## COMMENTS ON GROUNDWATER DISCHARGE PERMIT

By Charles Judd – October 26, 2009

Thank you for opportunity to comment on the proposed amendment to EnergySolutions Groundwater Discharge Permit (UGW450005). It seems that the permit review has been done in a professional and thorough manner. After our review it has become clear that there are a few other items that should be considered and a couple of small changes that should be made to the permit. These items are listed below:

Attachment 13-3

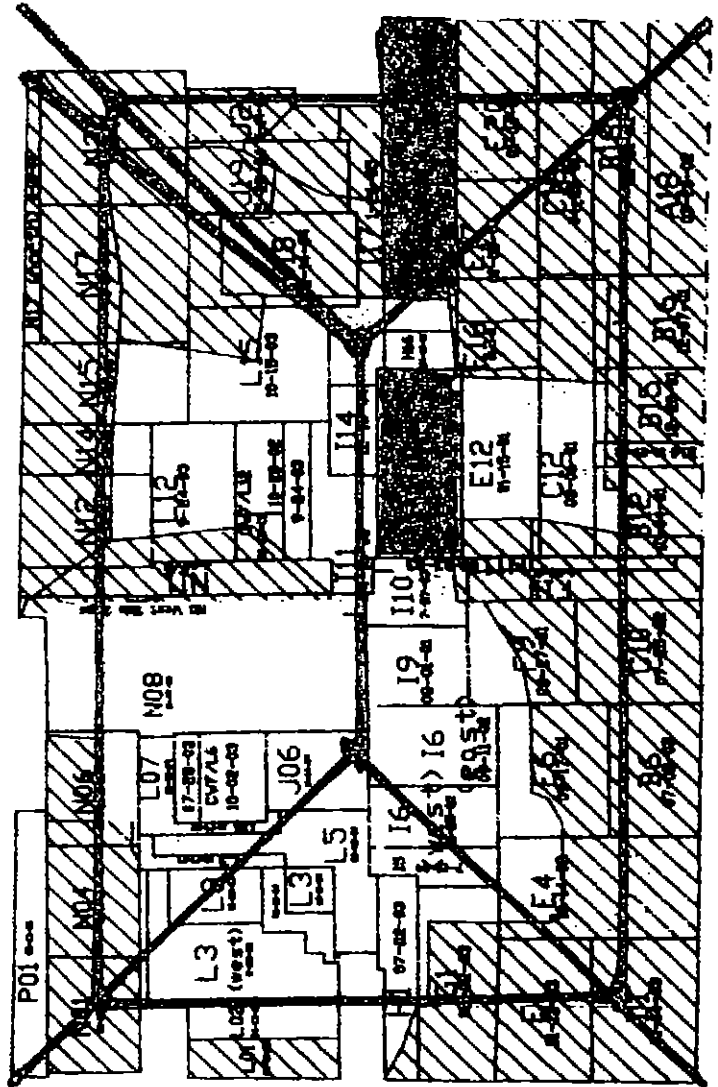
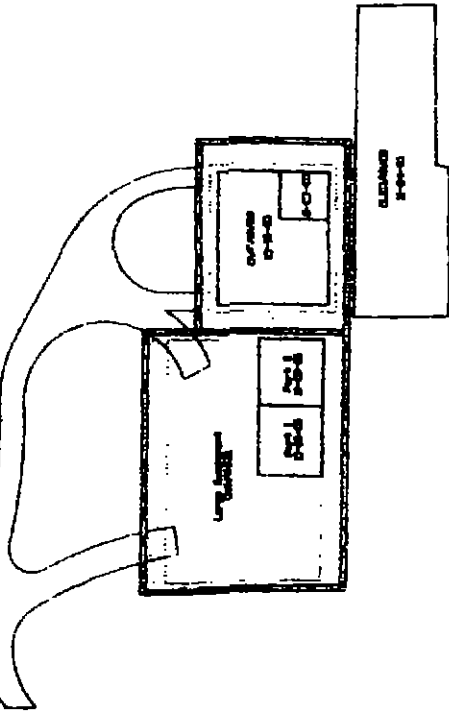
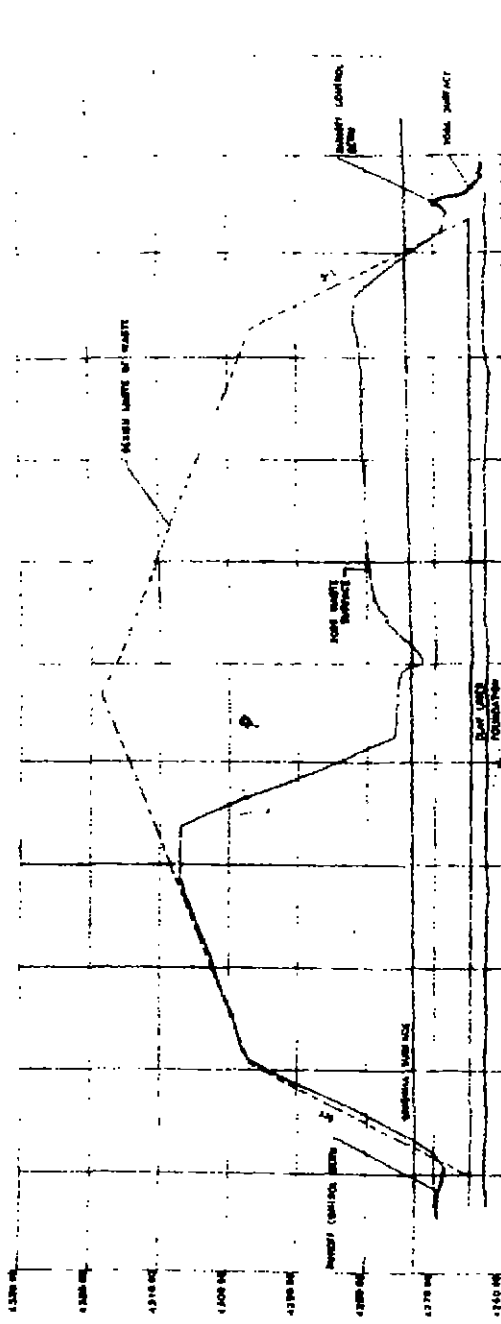
There are other rules to limit the spread of contamination. To limit the amount of water that passes through the embankment while the cell is open to the environment there is a set rule that states that the cell can only be open for 12 years before the final cover is completed. The State of Utah seems to have program where they monitor the amount of time that a cell is open. Attachment 13-1 is an example of the "Class A Open Cell Time Limitation Report." This report is a good summary of the different times in which cell areas were opened. From this report it is easy to see when a certain area needs to be closed with a final cover. Attachment 13-2 shows a map giving the locations of some of the lift areas of the Class A cells.

One of the problems is that you cannot close a small portion of the cell and have it function properly. For example it seems that the first area where waste was placed in the Class A cell was in an area referred to as H12, H17 and H20 (Attachment 13-3). Waste was first placed there in 2000. Therefore the final cover needs to be completed over these areas in 2012. The problem is that you cannot just put a cover over these areas. Attachment 13-4 shows a rough sketch of what the cell would look like if you placed a cover just over this area. The water flow off of the embankment would be adjusted. Water would penetrate into the embankment and down through the waste so that the 12 year limit was violated. The only way to make the 12 year open cell limit work is to cover larger areas of the embankment.

Attachment 13-4

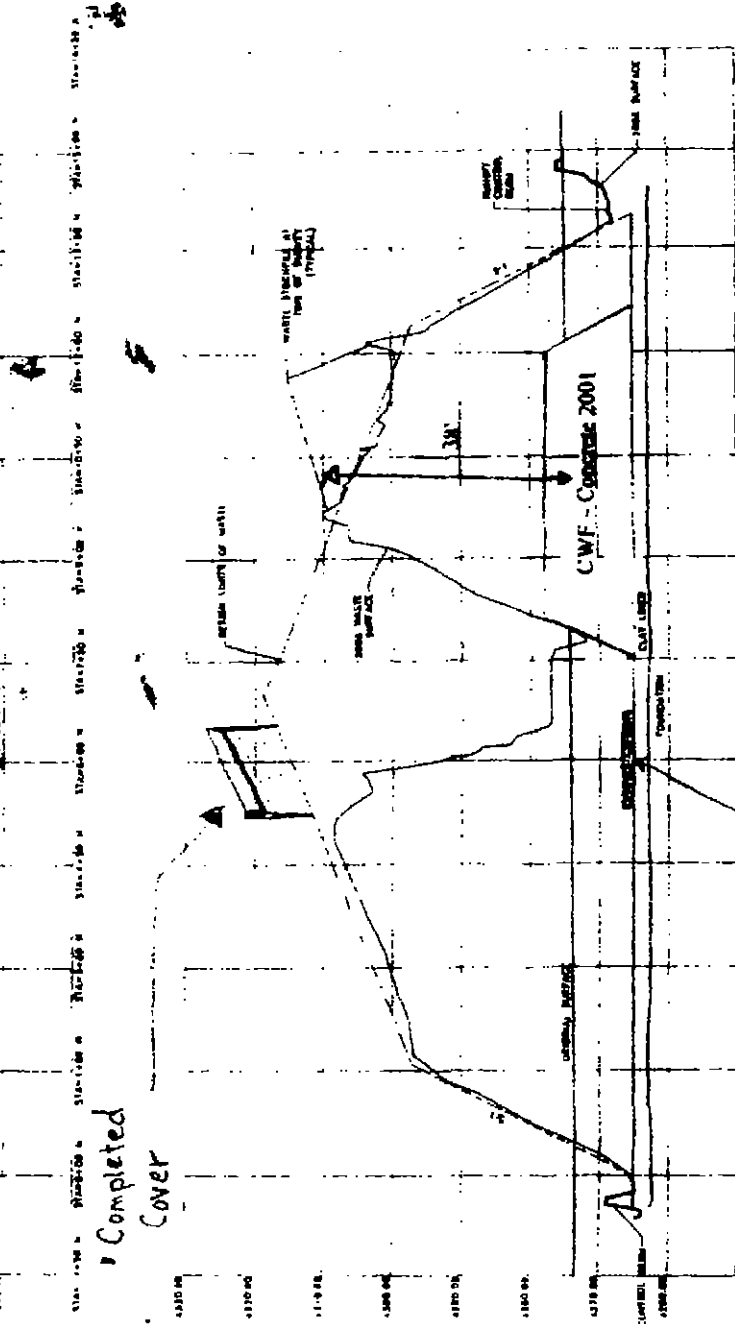
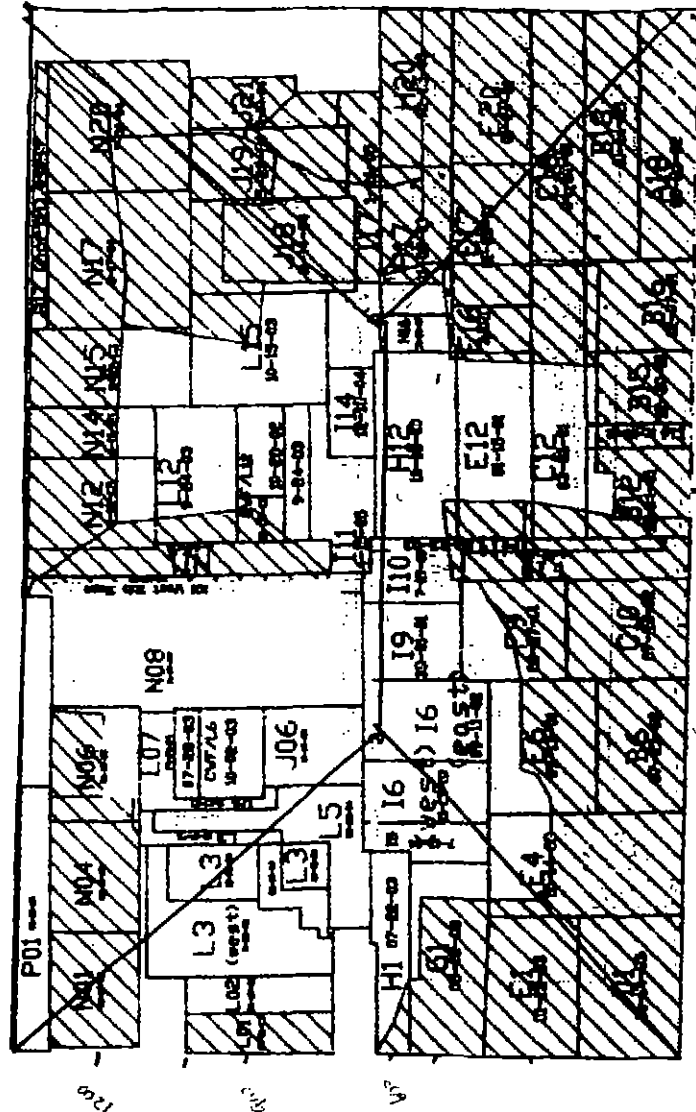
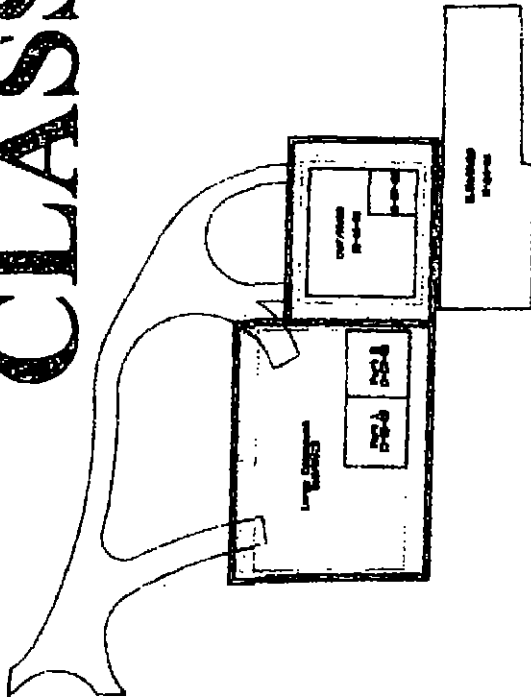
The reason that this is such a concern is that under the current plan the cells cannot be closed properly before the 12 year time expires. A look at Attachment 13-4 shows that at the end of 2006 the area over H12 has not been filled with waste. It is doubtful that is filled with waste even today. If you filled the area over H12 by the end of 2008 you could place the temporary cover over this material at that time. This waste column would have been placed quickly and would be next to an area where waste had been placed for about 5 years. This would mean that initial settlement would go on for at least 5 years. This is expected because of the data collected from the LARW cell. In five years the initial differential settlement may be done and then it will take about one year to construct the final cover. This means

that the cover cannot be completed properly until 2014. This would be a violation of the open cell limit of 12 years.

Therefore, even if work began to close this section right now there has to be a new plan to get the cell closed in 12 years. It may be necessary to surcharge the area. However, there is no data to know how much this will help in settlement efforts. It may be necessary to install some temporary synthetic liner to keep moisture out of the cell. The problem is that time has already run out and there is no proven way to close the facility properly.

## Attachment 7-2

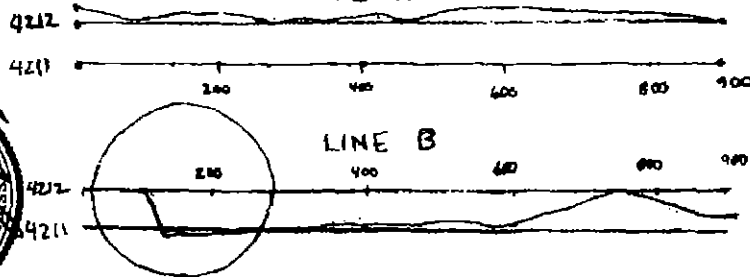
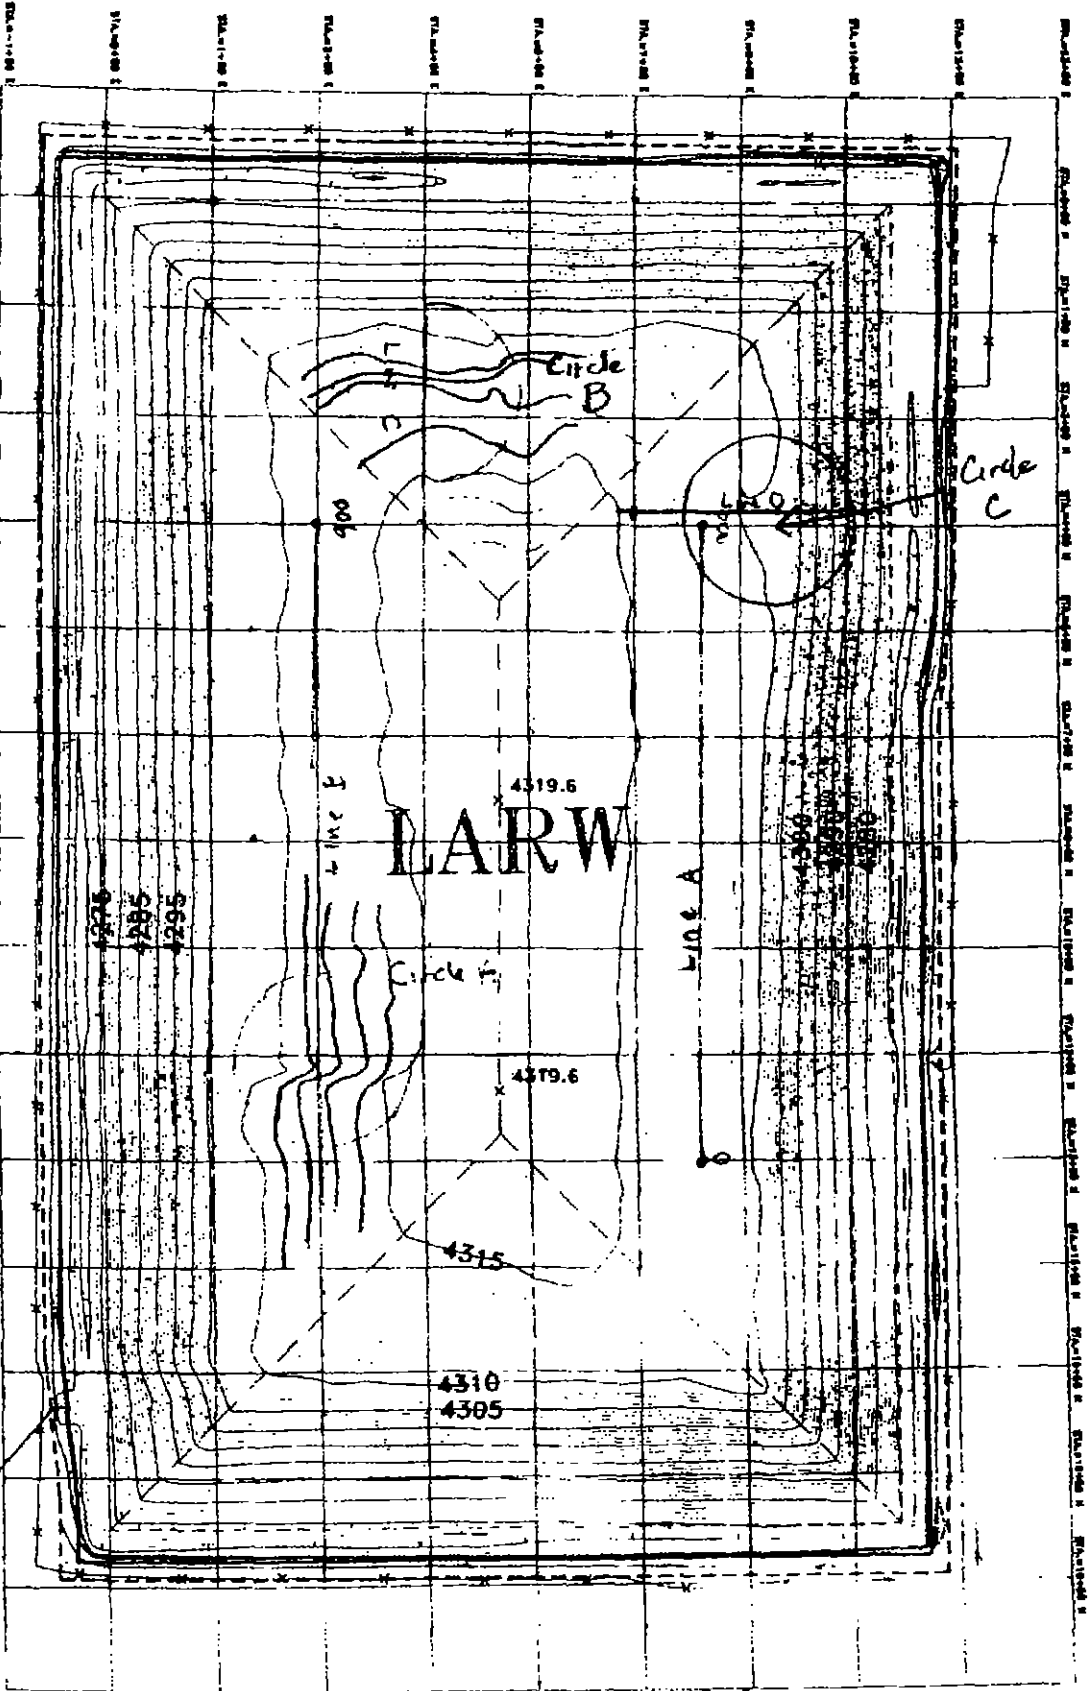
Attachment 7-1 is a map of the completed LARW cell at Clive. The map shows the contour lines as of the end of 2006. There are at least three areas of concern that can be seen just by looking at the contours. The problem areas are shown as Area A, B, and C. Attachment 7-2 shows a cross section of the cover system as it would have been constructed with the old design. The design allows for easy flow of water off of the embankment. Attachment 7-3 shows a cross section of Area C as it was at the end of 2006. In this area there is a section of the embankment that has shown slope reversal. The portion near the edge of the embankment is actually higher than a section of the embankment closer to the middle of the cell. The cross section shows the expected affect of this settlement on the layers of the cover below the rock erosion barrier. As the cover is now constructed the water that is collected in the filter zone begins to run toward the edge of the embankment. Instead of flowing off of the side of the embankment the water will pond and then increase the water infiltration into the radon barrier and also into the waste. The calculations of the amount of infiltration into the embankment do not account for the ponding of water on the top of the embankment.

New Design  
As-Built Originally

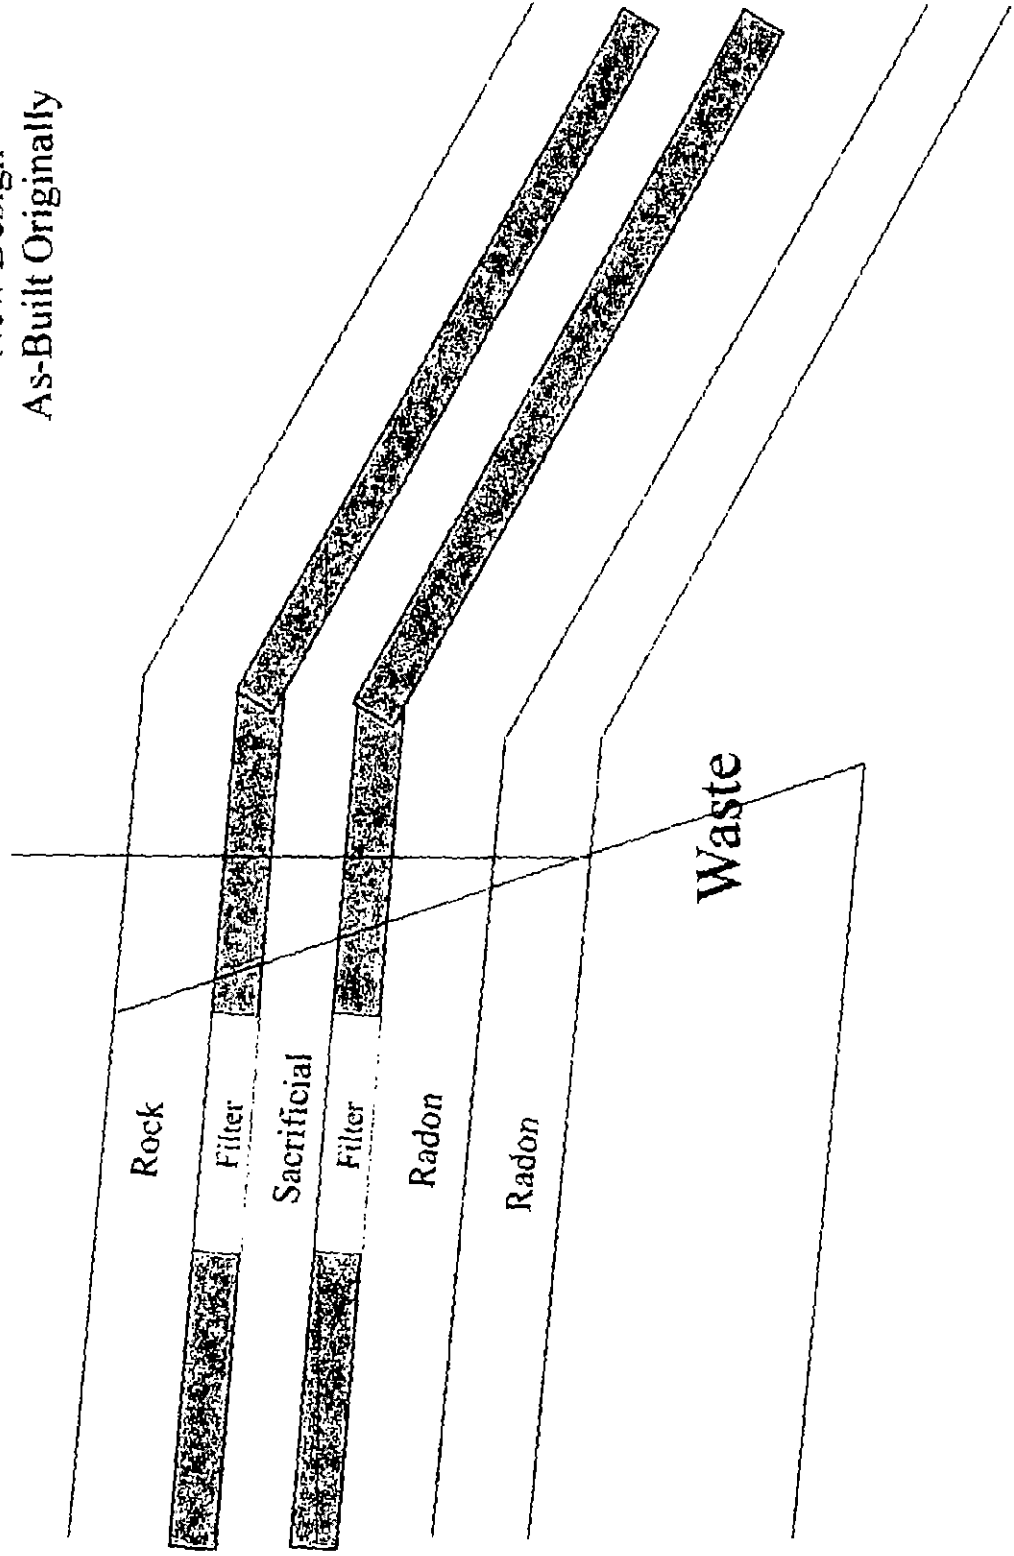
To make matters even worse the new Class A and CAN cells are planning on using a new design which reduces the radon barrier from 7 feet to 2 feet. This creates a much more serious situation because a two foot drop in the surface of the cover creates a much more drastic result. Please refer to Attachment 7-4 to see the new design as it would be originally constructed. Now look at Attachment 7-5 to see what will happen if we have the same settlement issues in the Class A cell as we have already seen happen in the LARW cell (in 5 years, let alone 1000 years). After settlement similar to what we have already seen then water that flows through the lower filter zone will go directly into the waste. From there it will flow quite easily through to the liner which will also be cracked. From there the contaminated water will have a clear path off site. In other words, if we have the same type of settlement with the new design as we have seen in the LARW then we will have a complete failure of the cover system. One would hope that the new methods would be more effective than the previous methods; however this is not the case.
